**STATE SIGNIFICANT INFRASTRUCTURE
ASSESSMENT:**

***WestConnex M5 King Georges Road
Interchange Upgrade***

(SSI 6547)

Secretary's Environmental Assessment Report
Section 115ZA of the
Environmental Planning and Assessment Act 1979

Figure 5: Proposed Crossing Arrangement for East-Bound Motorway Cyclists

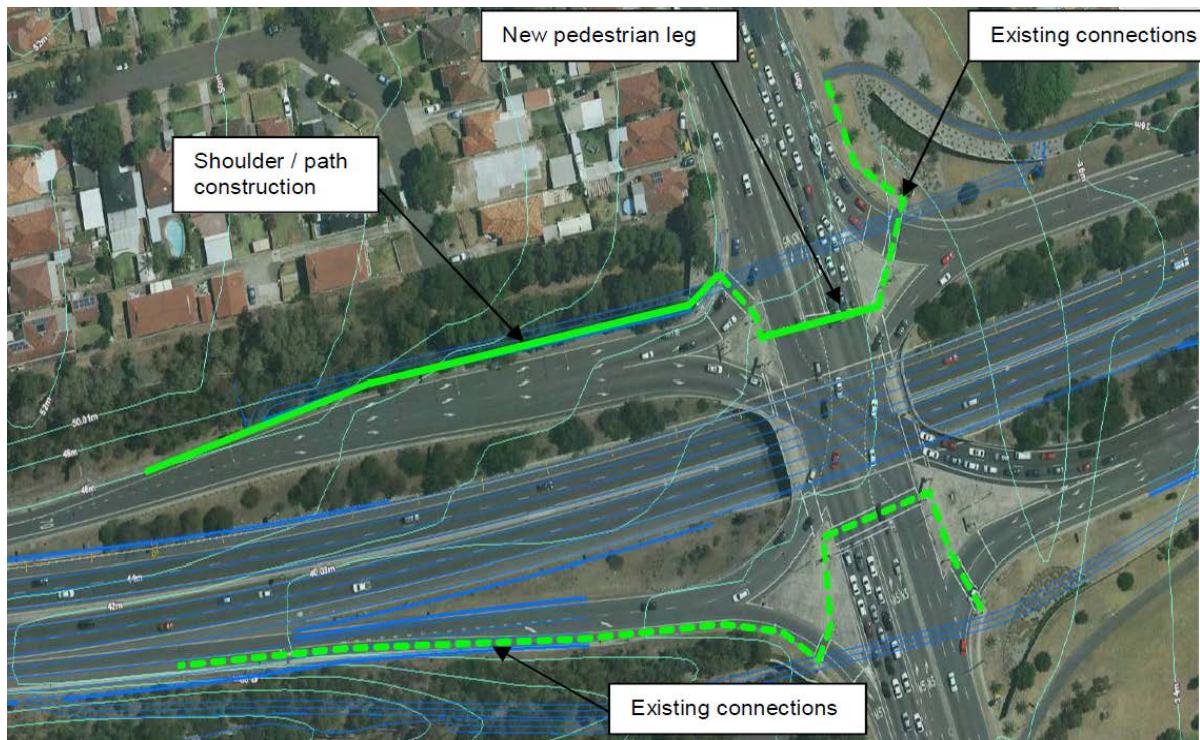
Further, in response to submissions and Council's position, the Proponent has reviewed its options for crossing King Georges Road. For east-bound cyclists exiting the M5 Motorway at King Georges Road, traffic signals at the eastbound off ramp and King Georges Road intersection would be re-phased to provide eastbound cyclists with a simpler, safer and more time-efficient route for crossing King Georges Road and accessing the shared path on the eastern side of the interchange. This would include:

- pedestrian traffic signals, on the eastbound exit ramp controlling the left turning traffic, will default to green;
- access across King Georges Road via a new pedestrian crossing between the traffic islands on the east bound exit ramp and the east bound entry ramp; and
- access to the existing shared path via the the pedestrian crossing on the east bound entry ramp.

The above arrangement effectively reduces the current movements to two movements in most cases. Details are provided in **Figure 5**.
